Date: March 07, 2007

To: T10 Committee (SCSI)

Subject: SAS-2: Transport level read fixes

Figure 1 — Representation of transport layer (i.e., ST_ITS6) read data operation

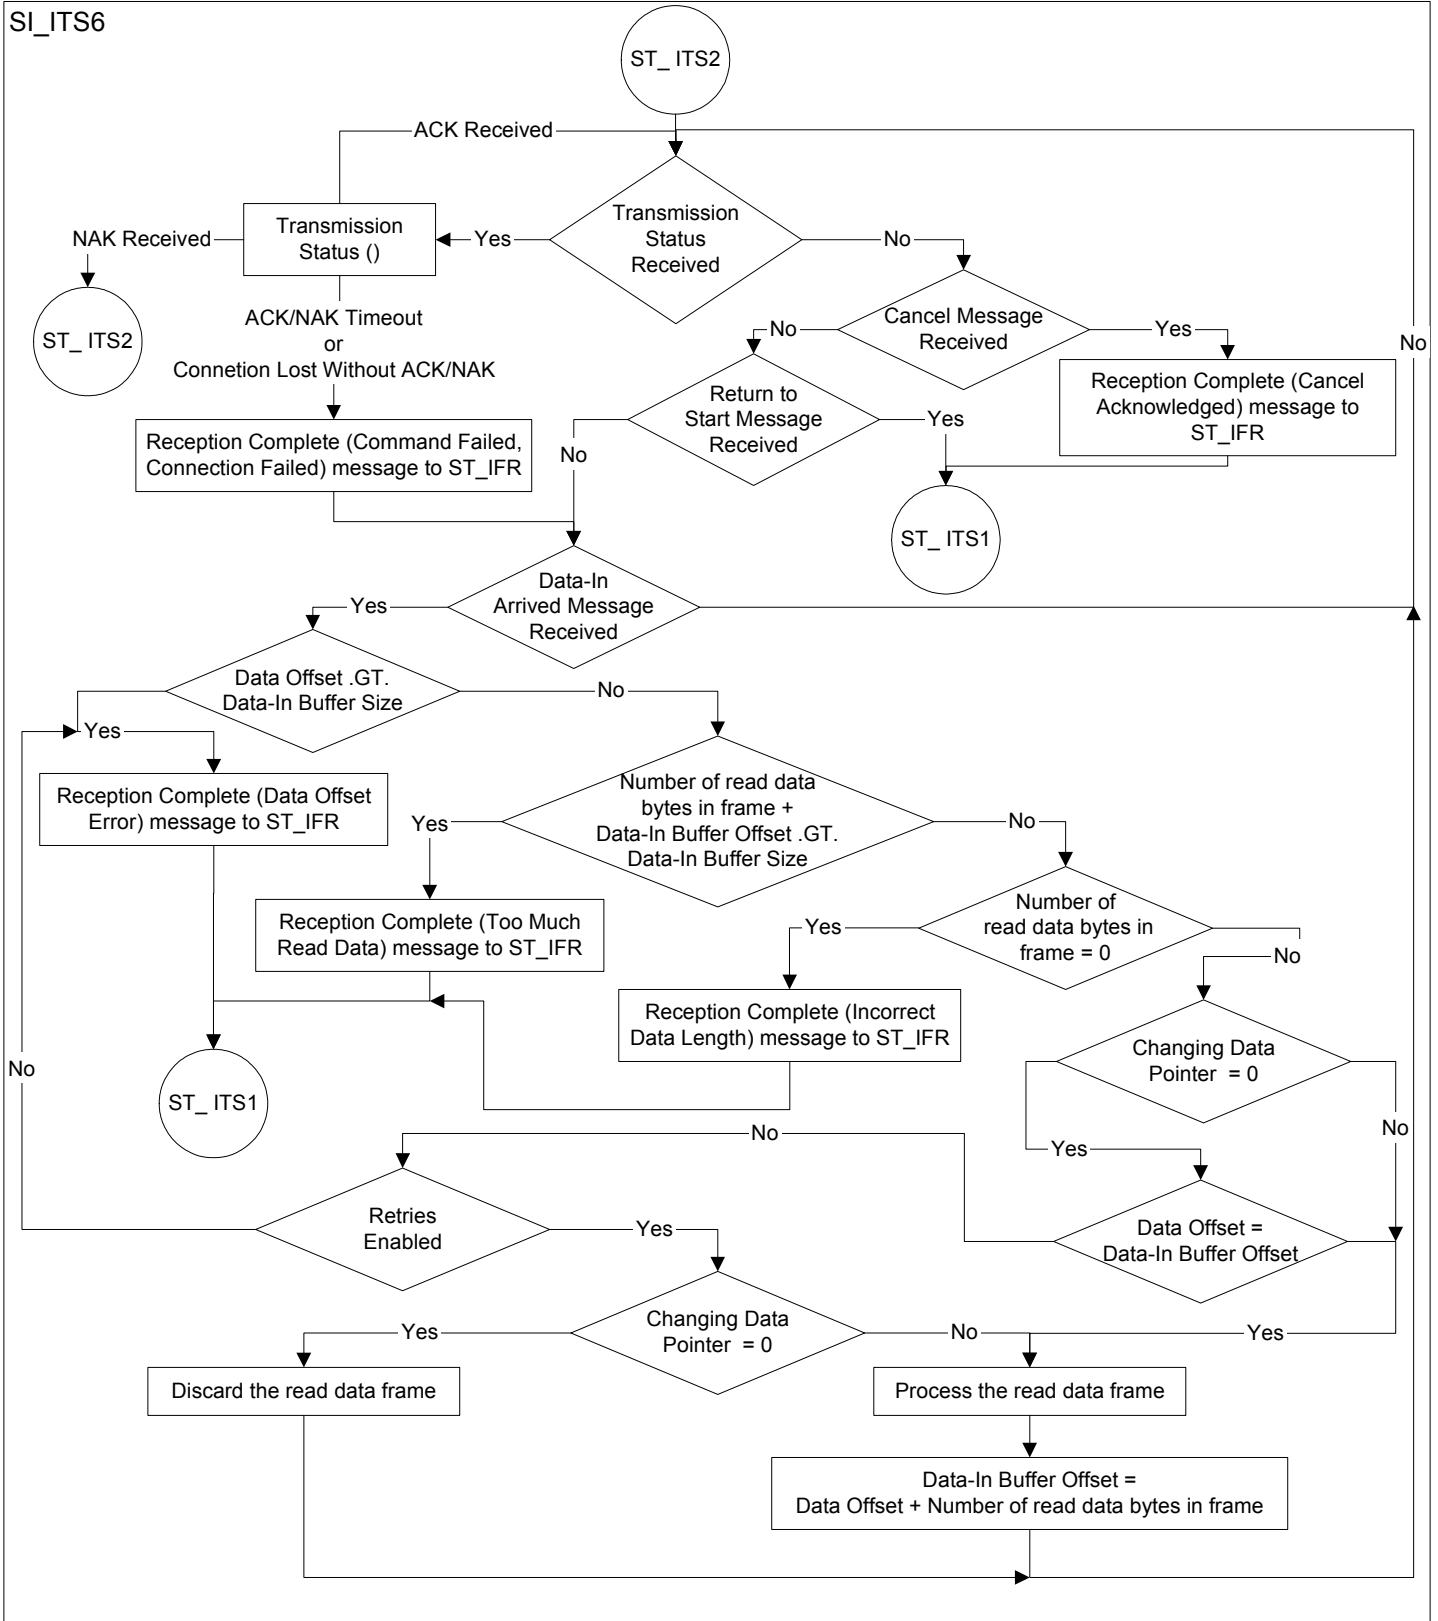
The below editors note suggests that the Data-in Buffer Size needs to be adjusted. But that value should never be adjusted as it is an argument and is only used to make sure none of the read data frames that are received will put data beyond the buffer allocated by the application.

Editor's Note 46: if Buffer Offset is an app client buffer based value, then Data-In Buffer Size needs to be adjusted.

The flow chart also needs to be adjusted as there are some errors in it (see figure 1).
